**Daniel J. MacDonald Modernization**

.1 The following Drawings are revised and re-issued with this addendum. Revisions are shown in bubbled areas on drawings. The following descriptions of revisions are for convenience only and do not define or limit the extent of actual revisions indicated on drawings:

End of NORR Addendum No. 7

3 FOURTH FLOOR MECHANICAL RISER DETAILS  
M60-01 SCALE: 1:50

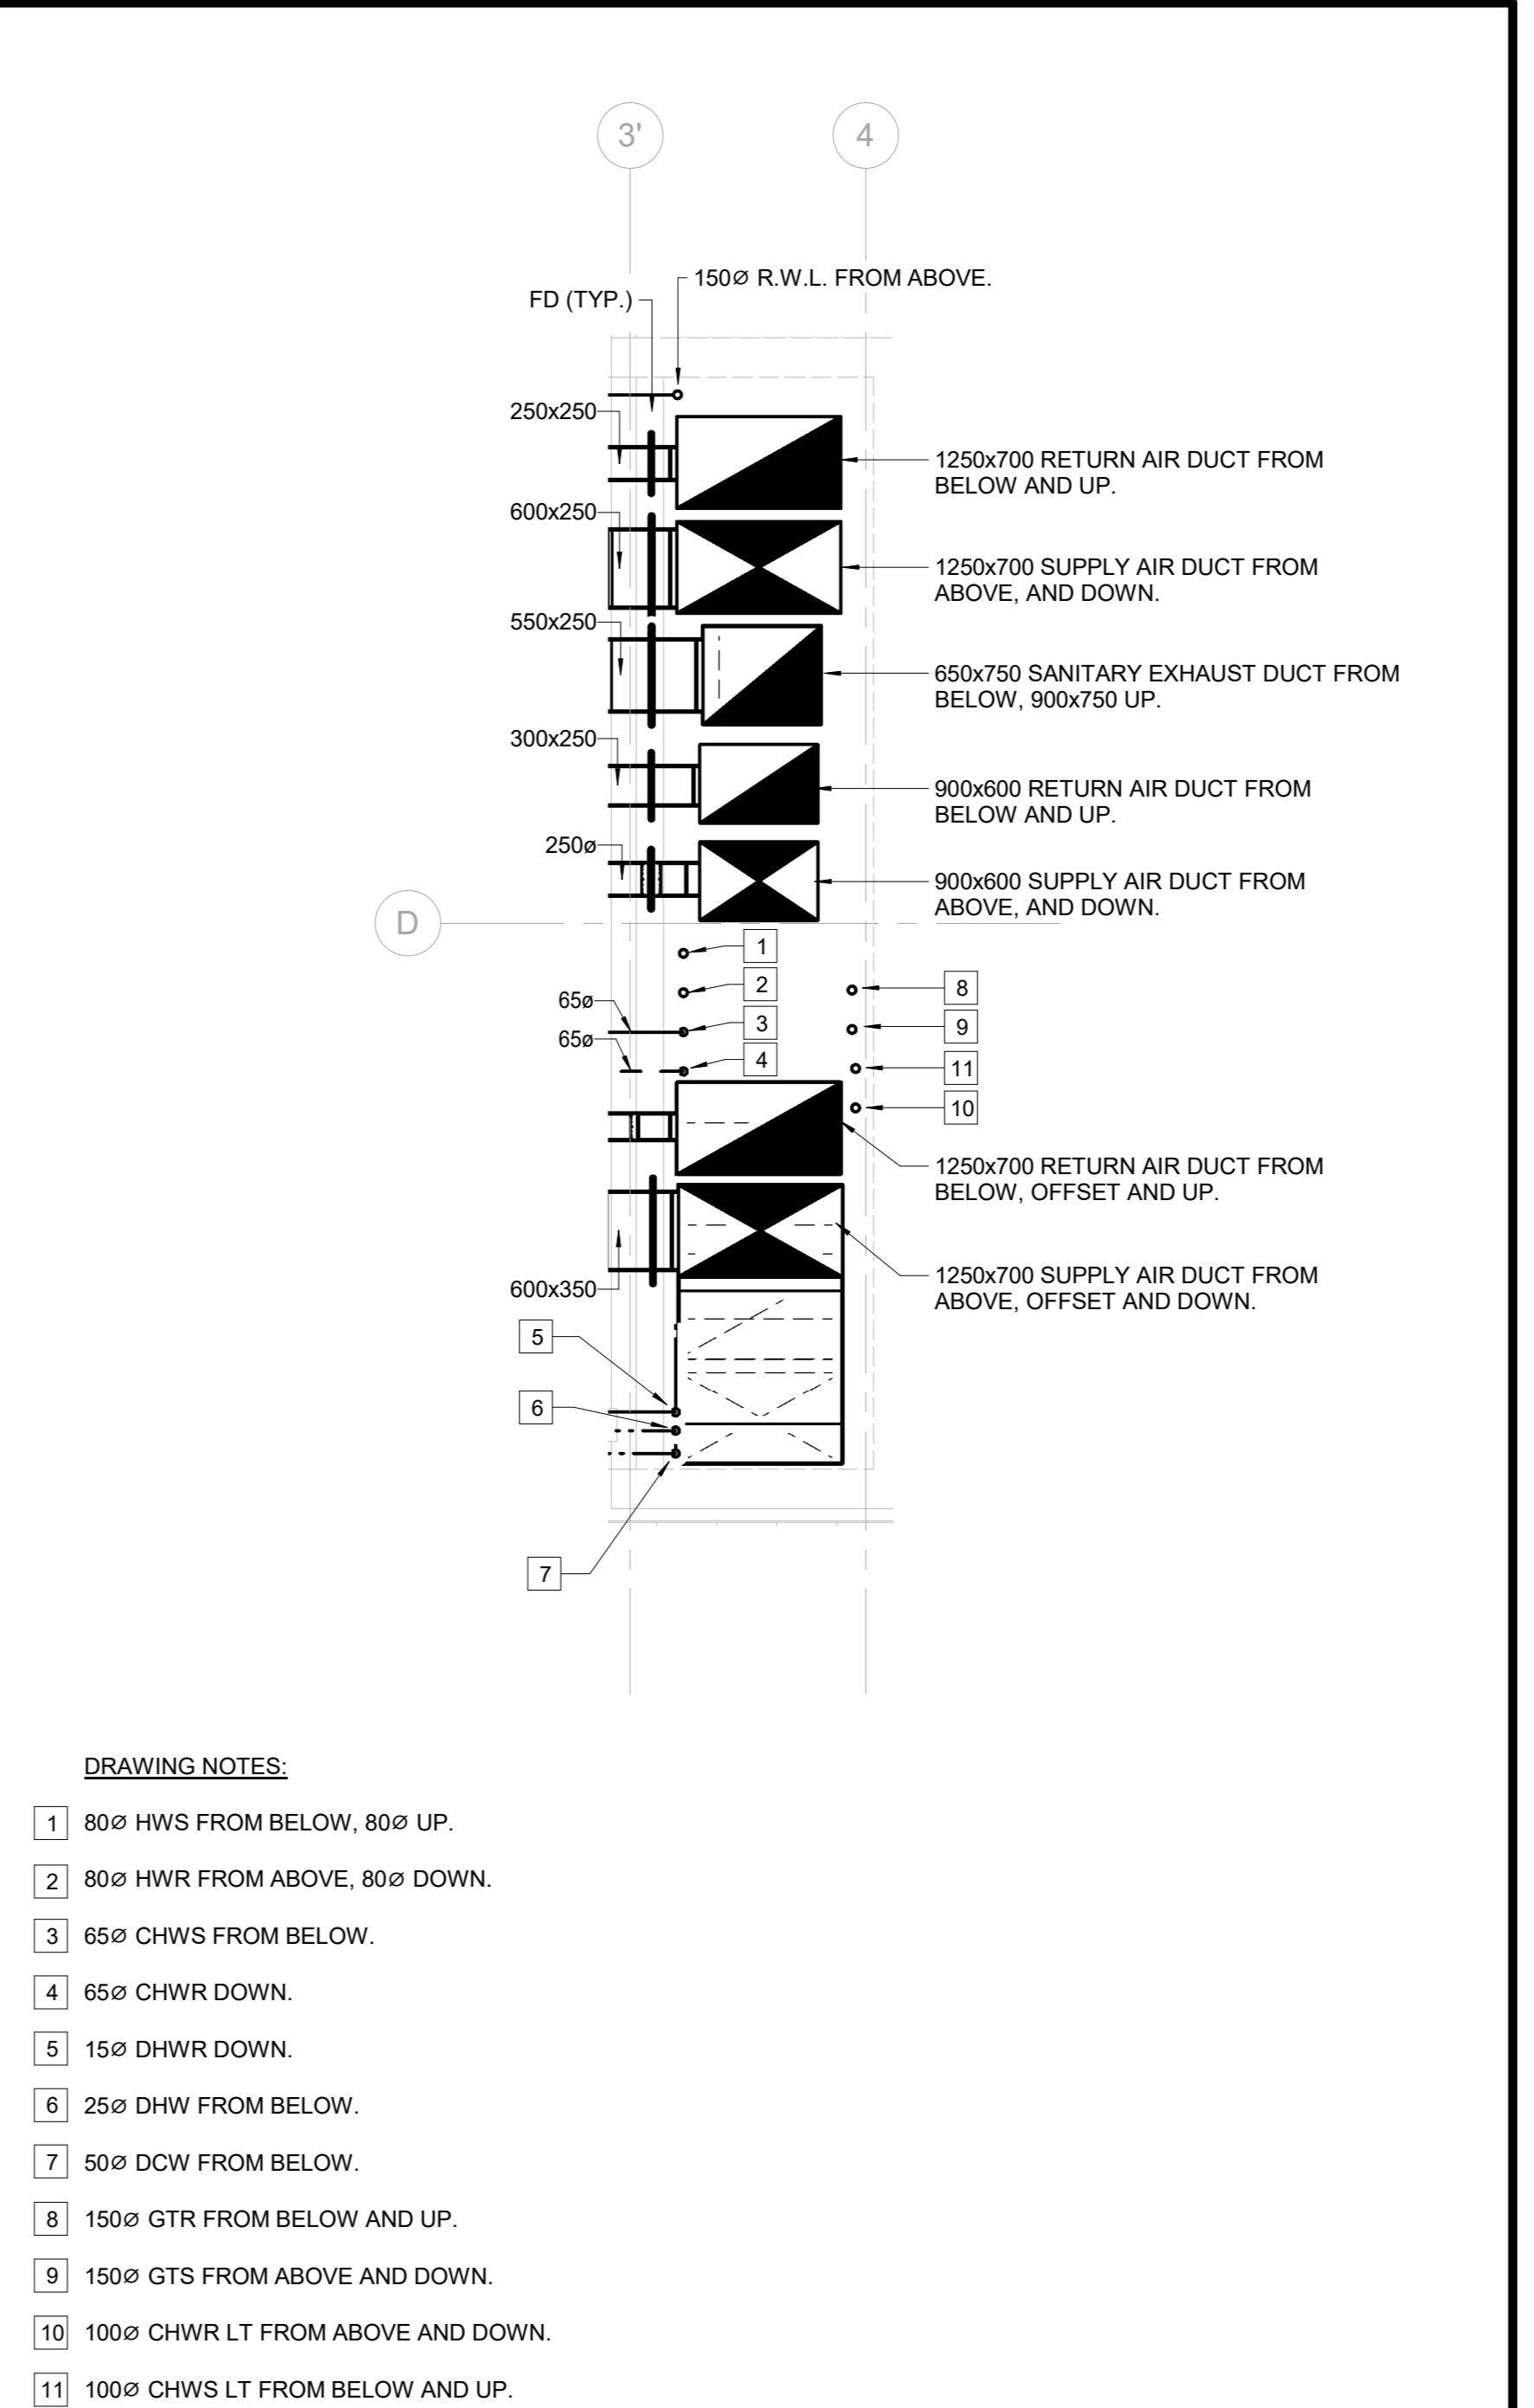
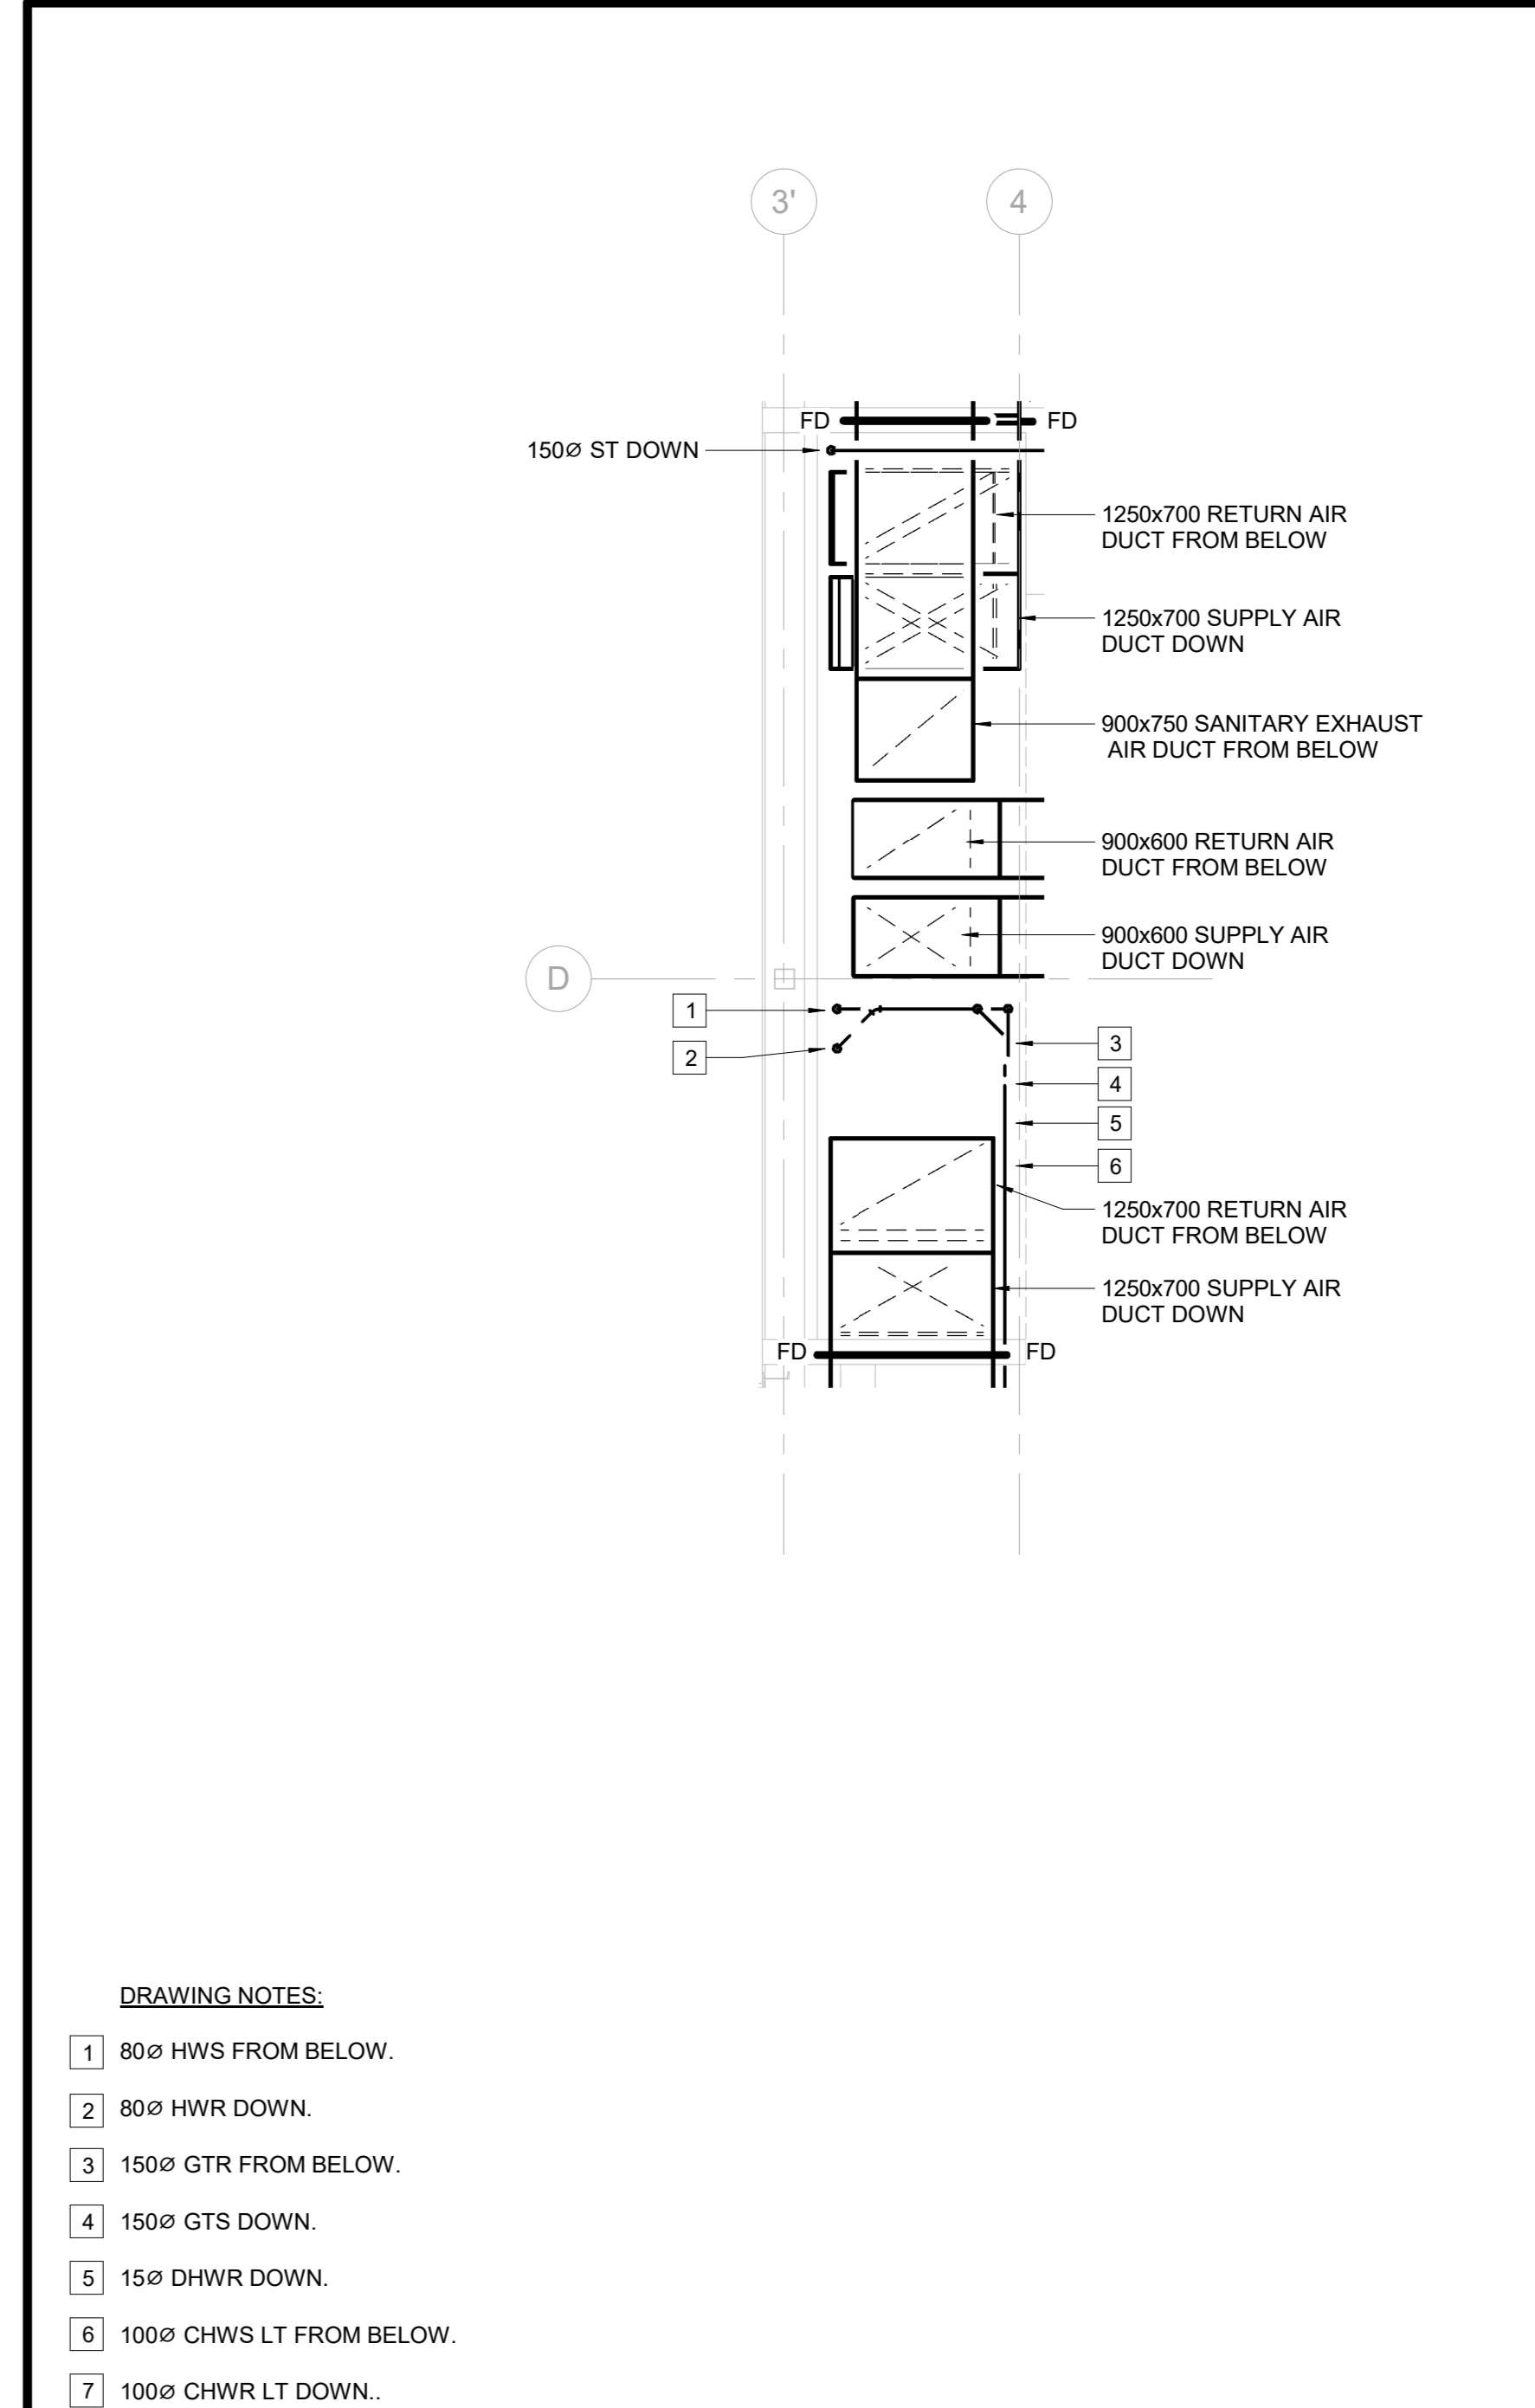
- .8 Drawing M53-06 - HYDRONIC - PENTHOUSE FLOOR NEW WORK
  - .1 Revised pipe sizes.
- .9 Drawing M60-01 - MECHANICAL RISER DETAILS PART PLANS
  - .1 Revised notes reflecting pipe sizes.
